IR2020-2.3 Avoidance and Mitigation Measures for Project Construction - Underwater Noise and Southern Resident Killer Whales

Background

In his letter of August 24, 2020 (CIAR Document #2067¹), the minister of environment and climate change (the minister) requested additional information regarding project construction avoidance and mitigation measures related to underwater noise and effects on southern resident killer whales (SRKW). The Vancouver Fraser Port Authority (the port authority) proposed the following construction-related mitigation measures during the environmental assessment process (CIAR Document #2001²) to avoid or reduce construction effects on SRKW, including the following:

Figure IR2020-2.3-1: SRKW peak use period based on monthly SRKW sightings within a 20 km radius of the proposed RBT2 terminal based on sightings data from 2009 to 2017

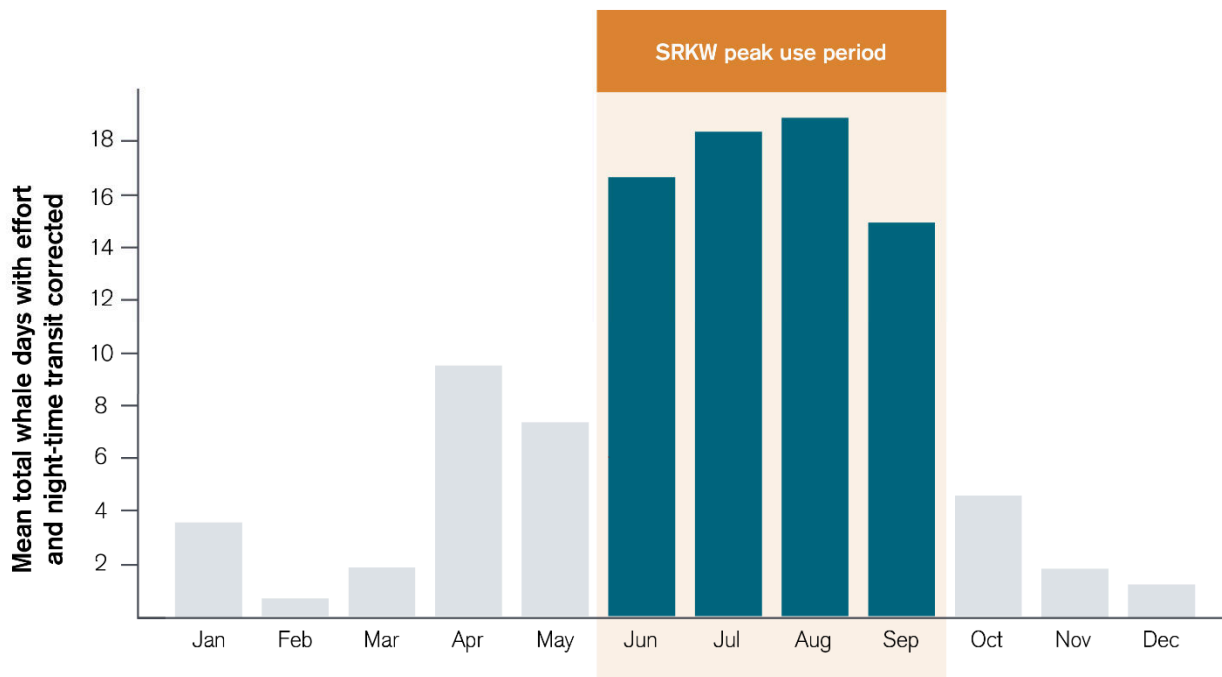
Minister’s request: Provide a plan that times construction activities to avoid potential effects on the Southern Resident Killer Whale based on seasonal habitat use.

These proposed mitigation measures are presented in **Appendix IR2020-2.3-D**. The SRKW seasonal habitat use of Roberts Bank (i.e., peak use period; **Figure IR2020-2.3-1**) was identified using the comprehensive datasets of SRKW sightings from the BC Cetacean Sightings Network (for Canada) and Orca Master (for the U.S.). The combined dataset, created for the environmental impact statement (EIS), was expanded to include six additional years (now comprising data from 2002 to 2017) (**Appendix IR2020-2.3-E**). Based on the 16-year dataset (n = 3,572 sightings), the three-month period from June 1 to August 31 captured over 50% of SRKW visits to the area, representing the time of year with the majority of the anticipated SRKW visits to Roberts Bank. Information recently published by DFO shows a high likelihood of SRKW presence at Roberts Bank in September (based on whale watching data from May to October 2009-2018; DFO 2021). Similarly, when considering trends from recent years (2009-2017), the comprehensive sightings dataset identifies June 1 to September 30 as the peak use period for SRKW at Roberts Bank (**Figure IR2020-2.3-1**).
